FINAL DRAINAGE REPORT
for
SILVERADO RANCH FILING NO. 2

JPS Project No. 080603
SF-24-___

SILVERADO RANCH FILING NO. 2 – FINAL DRAINAGE REPORT
TABLE OF CONTENTS

DEVELOPED DRAINAGE PLAN

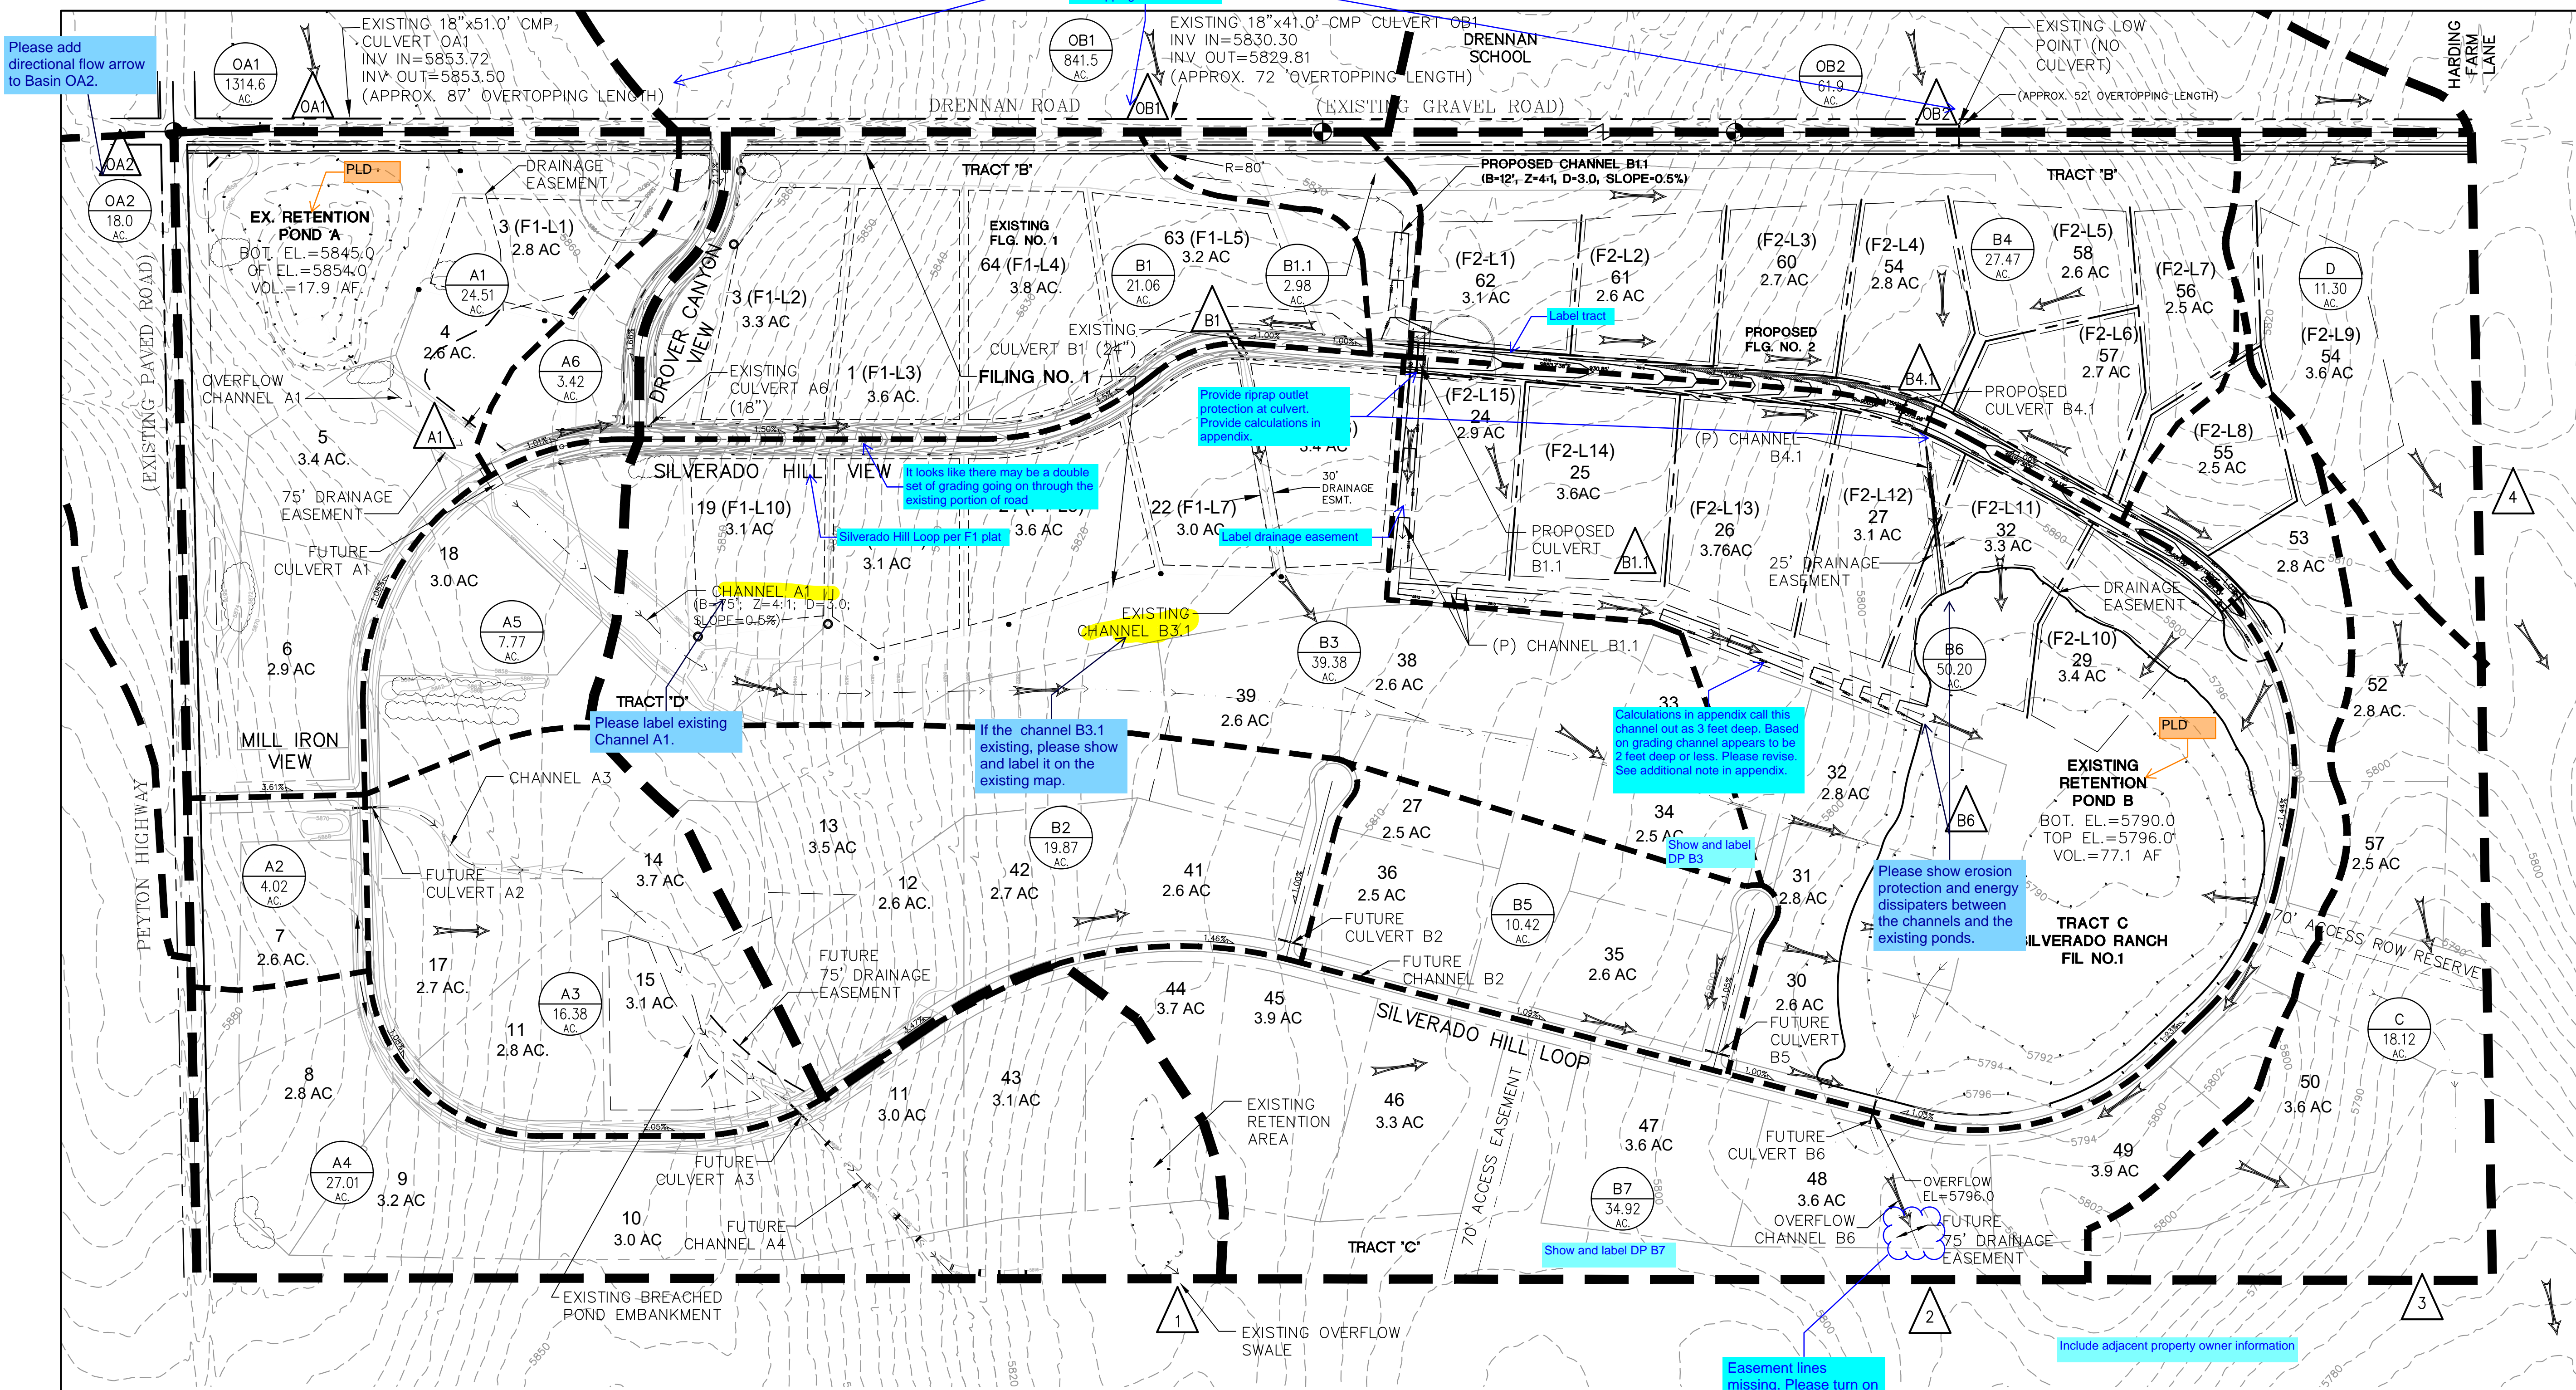
DP's OA2, OB2, B3 and B7 missing from summary table

- Include all basins and design points on the hydrology calculation spreadsheets which are shown on drainage maps.
- Turn off future improvements. If you want this information left in the report, refer to it as an "ultimate condition" map. Need to have proposed drainage map showing only existing and proposed conditions. Revise any drainage basins and routing as needed for this condition.
- List all storm facilities/structures as public or private

Provide cross sections for drainage channels B1.1 & B4.1

Please show erosion protection and energy dissipaters between the channels and the existing ponds.

Calculations in appendix call this channel out as 3 feet deep. Based on grading channel appears to be 2 feet deep or less. Please revise. See additional note in appendix.

Provide riprap outlet protection at culvert. Provide calculations in appendix.

Turn off future improvements. If you want this information left in the report, refer to it as an "ultimate condition" map. Need to have proposed drainage map showing only existing and proposed conditions. Revise any drainage basins and routing as needed for this condition.

Show and label DP B7

Show and label DP B3
